FOX WOOD GARDEN VILLAGE

INDICATIVE ELE/SECTION STONE WALL - FINAL

20285 IWE 04 H

Wall Elevation from Fox's Bank Lane (Section 1) - NTS

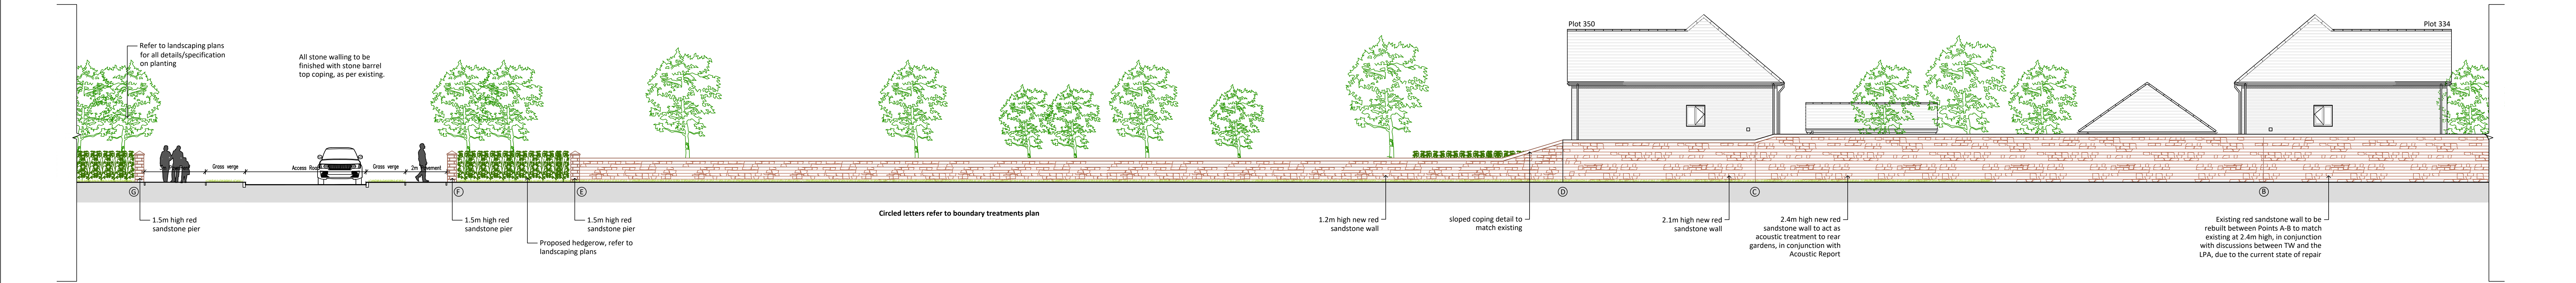
H	Following advice from TEP and approved by Clare Appleyard on 18/06/25, low level existing wall between J-K removed and replaced with mature hedge planting due to Health & Safety concerns regarding the proximity to existing tree and it's potential requirement for removal.	18/06/25	BB
G	Following site visit with Clare Appleyard 05/06/25, scope revised fronting Plots 26 & 27 due to lack of existing stone wall.	05/06/25	BB
F	Updated for clarity on height of rebuilt section A-B.	12/07/24	BB
E	Revised in line with As Built section, specification updated to St. Bees and Point A buffer shown.	27/02/24	BB
D	Revised in line with on site discussion with Stone Central & Knowsley MBC to increase the pillar width to 600x250mm.	20/10/23	BB
C	Revised in line with TEP's comments.	04/05/23	BB
B	Revised in line with Planner's comments.	09/03/23	BB
A	Revised in line with Planner's comments.	16/12/22	BB
